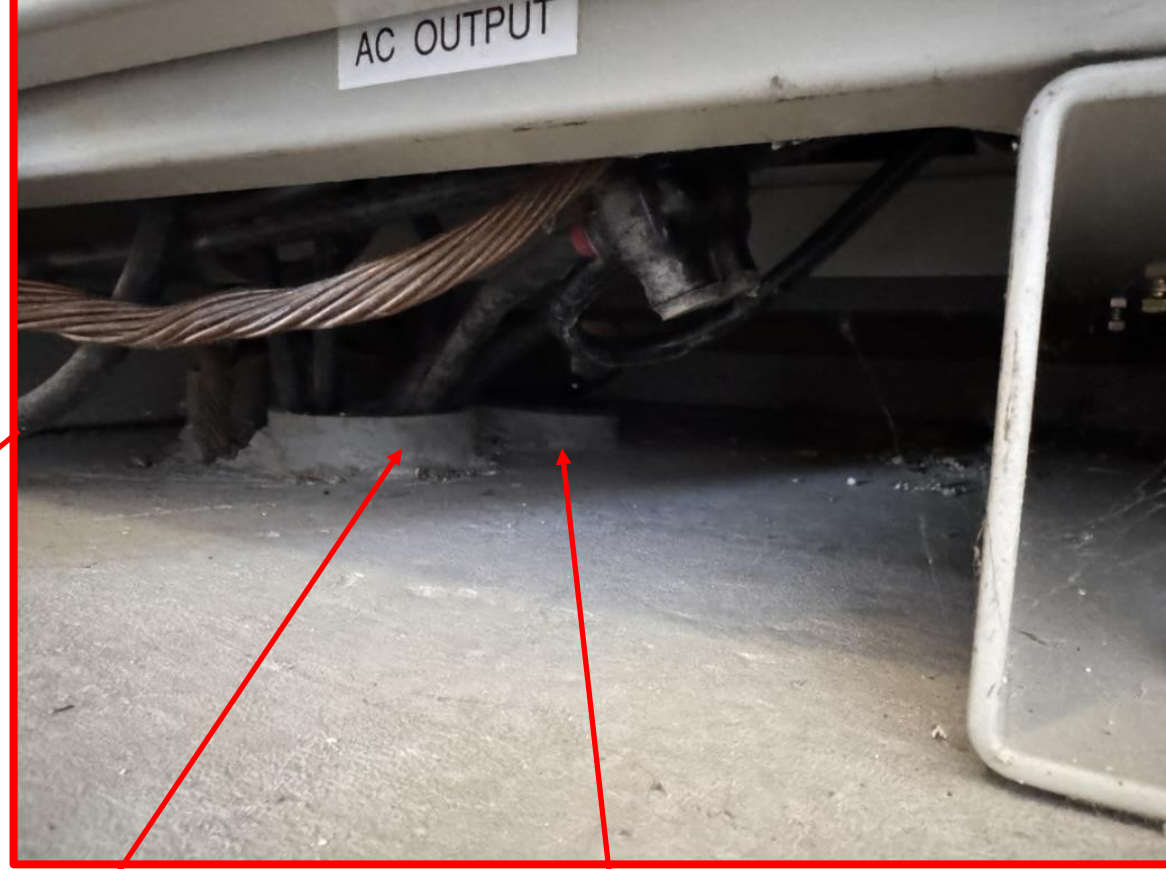
need to connect the 4 in conduit from
the ATS to the 3 in conduit going into
the UPS shed

need to remove the box here and
replace with a bend. This conduit will
be used to supply the PDP2 from the
UPS

Need to replace these two conduits with ones that have fittings and are not just stuck in the panel and sealed up with silicone

They go to the cable vault next to the fence and have all cable going to the different buildings and equipment on the observatory

empty 3 in conduit that
needs to be connected to
the 4 in one going to the
transfer switch

Need to replace these two conduits with ones that have fittings and are not just stuck in the panel and sealed up with silicone
